<b>Subject:</b>  <b>RATTLE NOISE FROM REAR STABILIZER</b>	<b>Bulletin No:</b> 02-005/12
	<b>Last Issued:</b> 10/18/2012

2010-2012 Mazda3 vehicles (except Mazdaspeed3) with VINs lower than JM1 BL \*\*\*\*\* 622215 (produced before March 01, 2012)

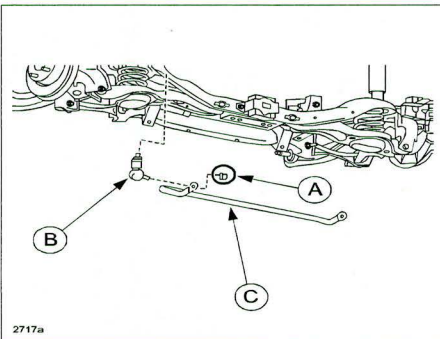
Some vehicles may exhibit a rattle type noise coming from the rear stabilizer when driving over a road bump. This noise may be caused by a loose rear stabilizer control link.

1. Verify customer concern.
2. Verify the rear stabilizer control link nut torque is below the 31.8 - 44.8 ft-lbf specification.
3. If loose, replace with new nuts (A). Refer to MS3 online or Workshop Manual (section 02-14 REAR STABILIZER REMOVAL/INSTALLATION).

**NOTE:** After removing the nuts, inspect the threads of the bolts. If wear exists, replace the control link.

Old Style Locking Nut	New Style Locking Nut
 <p style="font-size: small; margin-top: 5px;">2717a</p>	<div style="border: 1px solid black; padding: 5px; width: fit-content; margin: 0 auto;"> <p style="text-align: center; margin: 0;"><b>R</b></p> <p style="margin: 0;">43.1 - 60.8 N·m {4.4 - 6.2 kgf·m 31.8 - 44.8 ft·lbf}</p> </div> 	<div style="border: 1px solid black; padding: 5px; width: fit-content; margin: 0 auto;"> <p style="margin: 0;">45.0 - 55.0 N·m {4.6 - 5.6 kgf·m 33.2 - 40.6 ft·lbf}</p> </div>
Item	Description	
A	Locking Nut	
B	Rear Stabilizer Control Link	
C	Rear Stabilizer	
D	Old Style Locking Nut	
E	New Style Locking Nut With Identification Marks
